AMENDED IN RED

PLANS AND DOCUMENTS referred to in the PDA DEVELOPMENT APPROVAL

Approval no: DEV2020/1121

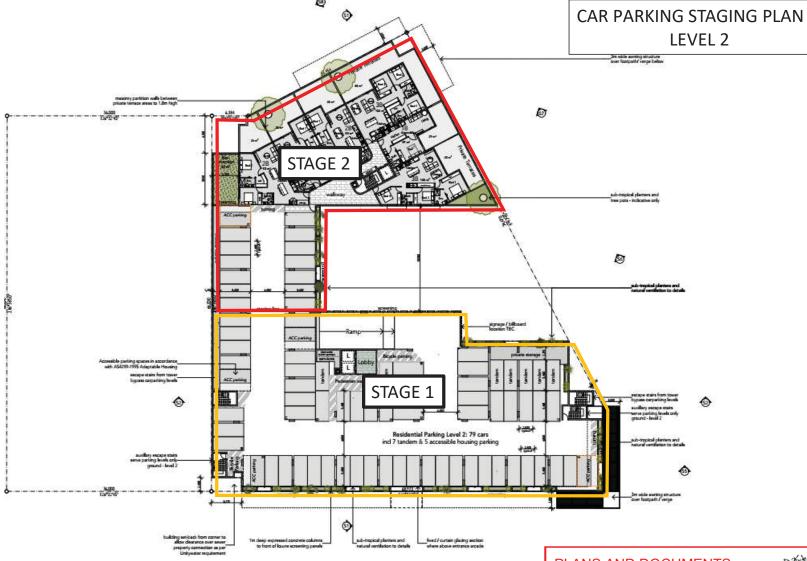
49.000 Level 14 46.100 Level 13 43.200 Level 12 opaque glass f500mm -high from floor level to western glazing 40.300 F Level 11 37.400 Level 10 34.500 Level 9 31.600 Level 8 28.700 solid balustrades Level 7 up to 1m min. 25.800 opaque glass 1500mm high from floor level to western glazing Level 6 22.900 STAGE 1 Level 5 STAGE 2 20.000 Level 4 17.100 Level 3 14.200 Level 2 11.000 Level 1 8.100 SUNSHINE COAST **FUTURE WAY** Clear access maintained for Service Vehicles exiting PARADE

via Future Way during Stage 2 construction
